Advisory Action

09/881,043

ATTACHMENT to ADVISORY ACTION

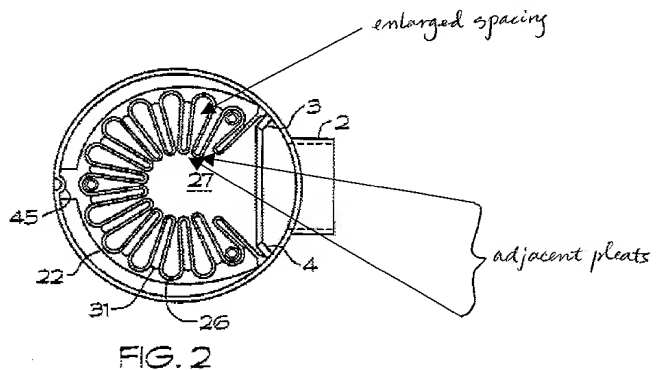
2. Applicants' arguments filed 11- 7-03 have been fully considered but they are not persuasive. The examiner does not agree with the applicants' contention that the prior art, Nurse (US 5,593,584) which is used in the rejection of the base claim 10 in the final office action, fails to teach all the limitations of the base claim 10. Applicants' have argued that Nurse has failed to teach the filter medium to be a pleated filter sheet. What the examiner has considered to be the "filter medium" is the sinuous shaped (zig-zag shaped) sheet/strip or dam (indicated as 26) which *prevents larger sized/heavy particles* from overflowing into the other side of the strip. Although it may be true that the dam/sinuous strip (26) is impermeable (non-porous), however, this is considered immaterial, since filter media are generally available in various forms including those which are porous and non-porous. There is no recitation or teaching either in the claims nor the original disclosure that the filter medium of the claimed invention has to be (i.e. must be) porous. The fact that the pleated/sinuous shaped strip (26) is used to separate one type of matter, in this

instance, solid larger-sized or heavy particles from another (i.e. the fluid) that contains the solid larger-sized or heavy particles.

3. Regarding the second argument that Nurse also failed to disclose/teach a pocket of the pleated filter medium being formed by an enlarged spacing between two adjacent pleats. Using the same figure 2 that the applicants allege that does not show/teach enlarged spacings between two adjacent pleats, what the examiner considered to be the two pleats which are adjacent being those pleats which surround or enclose adjacent openings/slots (31) and the enlarged spacing being defined by the pocket/space that each pleat formed between those two adjacent pleats defining the slots/openings (31), wherein in three of such pockets, there is a rod (30) passing through holes (35) formed in those pockets/enlarged spacing. In the figure 2 below, the arrows correspond to the enlarged spacing and the two adjacent pleats.
